# Access Compliance Report

## Public Rights-of-Way

### (Curb Ramps)

Intersection ID: 6384	Main Street: TOM_SADLER_RD	Cross Street: KINGSWAY_CR	Location: W
ADA ID: 26F4A04F8507	Ramp Type: Perp	Initial Pass/Fail: Fail	Overall Compliance: No
			Severity Score: 26.25

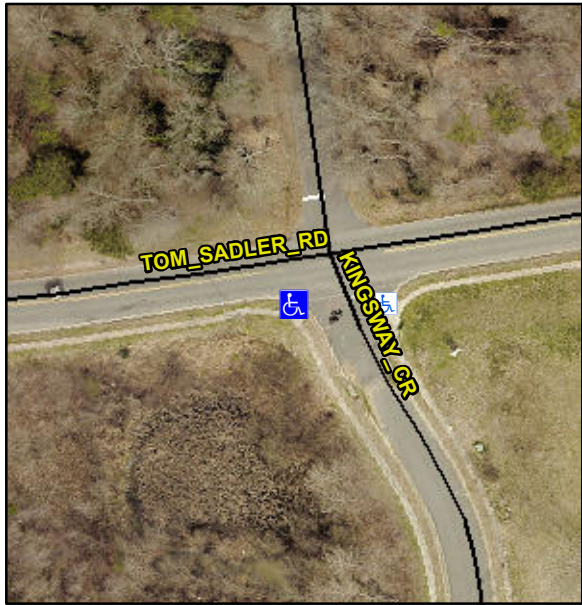
Codes/Mitigation Info/Possible Solution			Field Measurements/Component Compliance					
	Possible Solutions:		Compliance	Description	Data	Compliance	Description	Data
	Remove & Replace Entire Ramp.		N/A	Ramp Length (in)	54.5	No	Ramp Slope (%)	16.4
			Yes	Ramp Width (in)	48.0	No	Ramp XSlope (%)	3.5
			N/A	Flare Type LT	N/A	N/A	Flare Type RT	N/A
			N/A	Flare Slope LT (%)	N/A	N/A	Flare Slope RT (%)	N/A
			N/A	Flare Traversable LT?	N/A	N/A	Flare Traversable RT?	N/A
			N/A	Landing Length (in)	N/A	N/A	DWS Provided?	N/A
			N/A	Landing Width (in)	N/A	N/A	DWS Contrast?	N/A
			N/A	Landing Slope (%)	N/A	N/A	DWS Length (in)	N/A
			N/A	Landing X Slope (%)	N/A	N/A	DWS Full Width?	N/A
Surveyor Notes:	N/A		N/A	Landing Curb? (Y/N)	N/A	N/A	DWS Offset (in)	N/A
			N/A	Shared Landing?	N/A			
	PROW/ADA:		N/A	Gutter Ponding?	N/A	N/A	Gutter Slope (%)	N/A
	Not Found, R304.2.2, R304.5.3		N/A	Gutter Lip Ht (in)	N/A	N/A	Gutter X Slope (%)	N/A

N/A	Painted X Walk1?	No	N/A	Painted X Walk2?	N/A
				X Walk 1 Direction	To E		X Walk 2 Direction	N/A
			N/A	X Walk 1 Width (in)	N/A	N/A	X Walk 2 Width (in)	N/A
				X Walk 1 Slope (%)	6.3		X Walk 2 Slope (%)	N/A
				X Walk 1 X Slope (%)	2.5		X Walk 2 X Slope (%)	N/A
			N/A	Ramp inside XWalk1?	N/A	N/A	Ramp inside XWalk2?	N/A
Street 1 Name KINGSWAY CR Stop Condition-Street 2 None Street 2 Name N/A Stop Condition-Street 1 N/A				Road Slope (%)	N/A	N/A	Clear Space?	N/A
				Road X Slope (%)	N/A	N/A	Clear Space to XWalk (in)	N/A
			N/A	Any Obstructions?	N/A	N/A	Storm Grate/Utility Hazard?	N/A
				Obstruction Type			Storm Grate/Utility Type	
						N/A		N/A
						Yes	Surface Condition? (G/P)	Good
Total Cost:		\$	1850.00
